**TOWN OF NEWBURGH
PLANNING BOARD
TECHNICAL REVIEW COMMENTS**

PROJECT NAME: SCANNELL-NEWBURGH COMMERCE CENTER
PROJECT NO.: 2021-21
PROJECT LOCATION: SECTION 95, BLOCK 1, LOT 58
REVIEW DATE: 14 JANUARY 2022
MEETING DATE: 20 JANUARY 2022
PROJECT REPRESENTATIVE: LANGAN ENGINEERING

SITE PLAN APPROVAL DOCUMENTS FOR NEWBURGH COMMERCE CENTER

EROSION AND
SEDIMENT
CONTROL PLAN

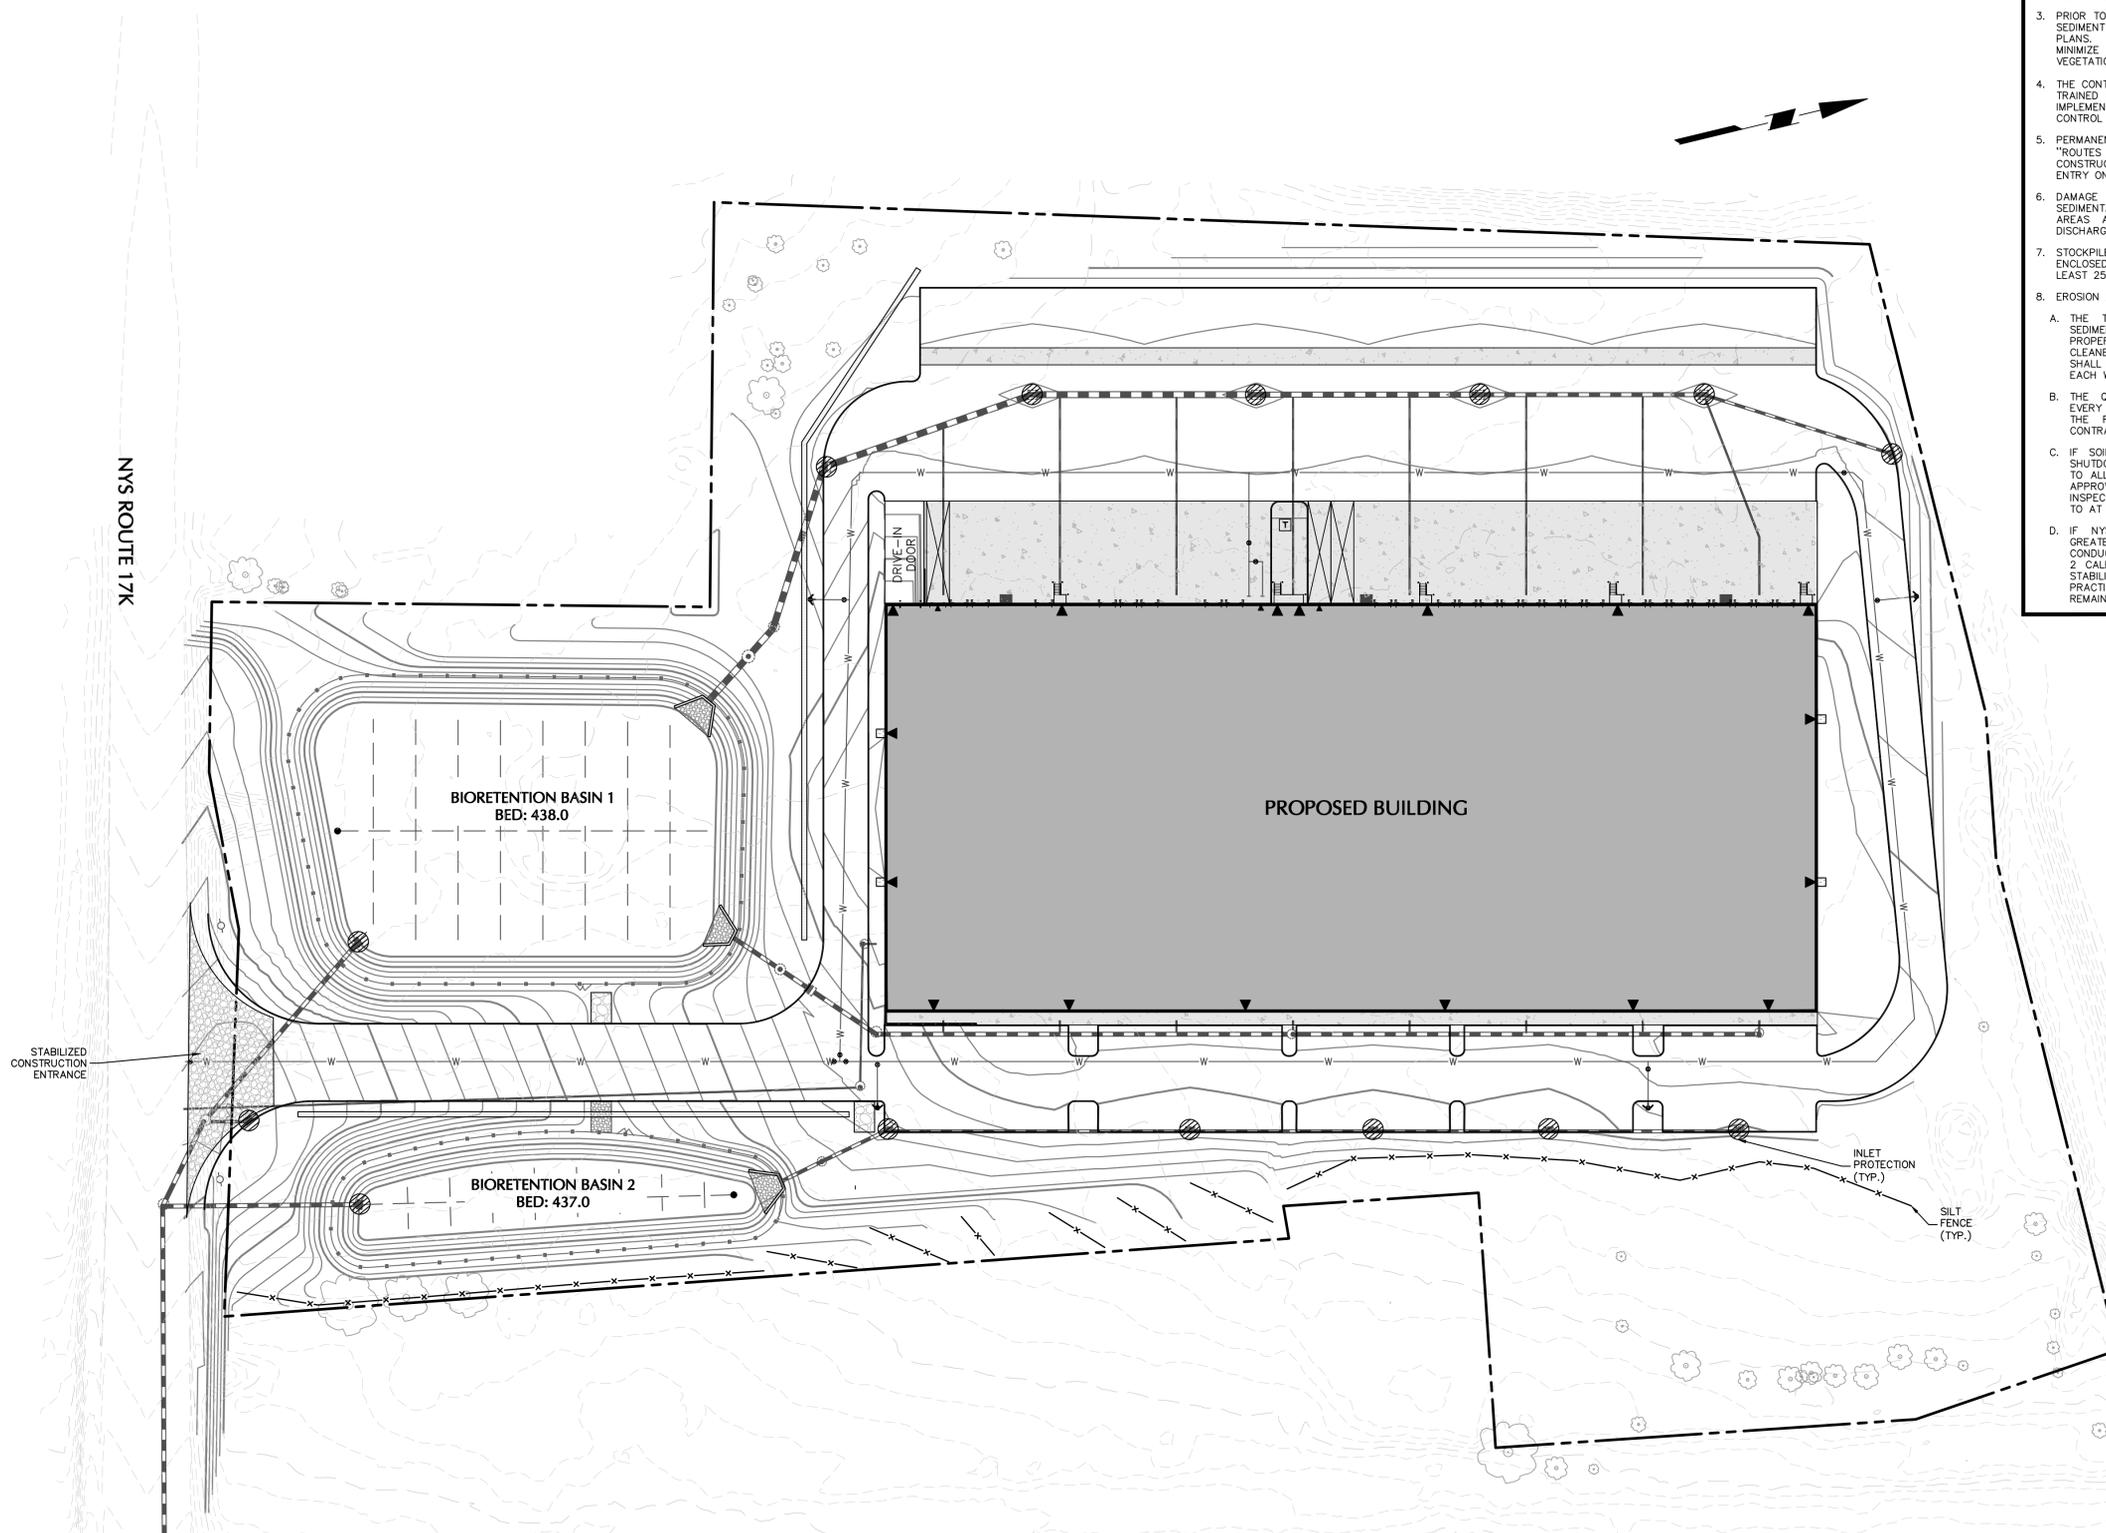
16. It is requested the Erosion & Sediment Control Plan address interim drainage condition along the easterly and westerly property lines existing and proposed grades.

17. It is unclear if temporary sediment traps are proposed on the plan. No detail or discussion of the same are provided. Volume of the temporary sediment traps should be calculated and identified.

SOUND WALL

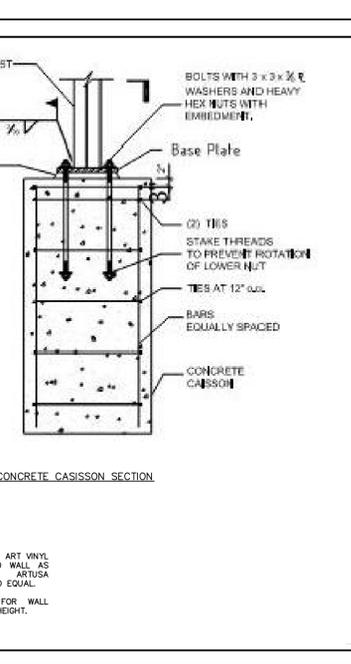
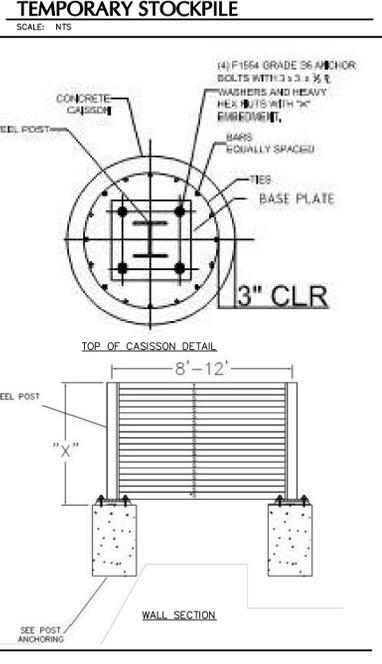
8. Noise Study should document the benefits of the sound attenuating wall proposed along the front of the parcel between the residential parcels and the subject property. In addition, a sound attenuating wall is provided along the easterly portion of the access drive.

BIORETENTION 1 OUTLET CONTROL STRUCTURE OCS-22
SCALE: NTS

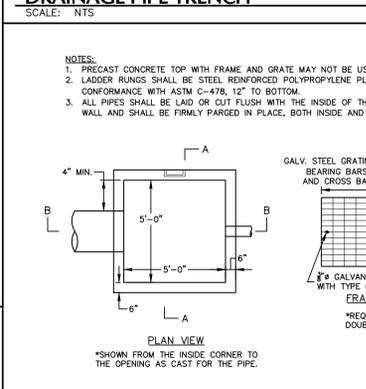
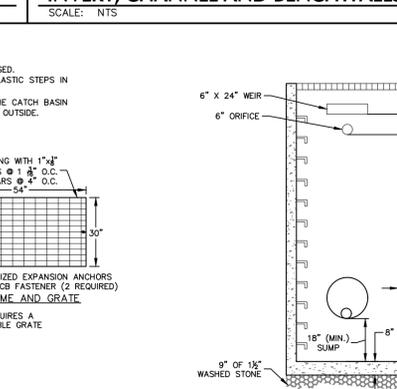
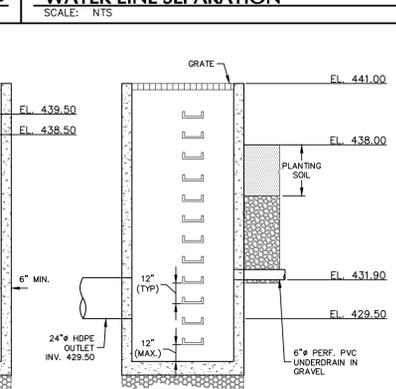
11. It is noted in the Stormwater Model that bio-retention area #1 identifies a .25 inches per hour exfiltration in the calculation. This is a lined pond which also then takes credit for the six inch vertical underdrain.
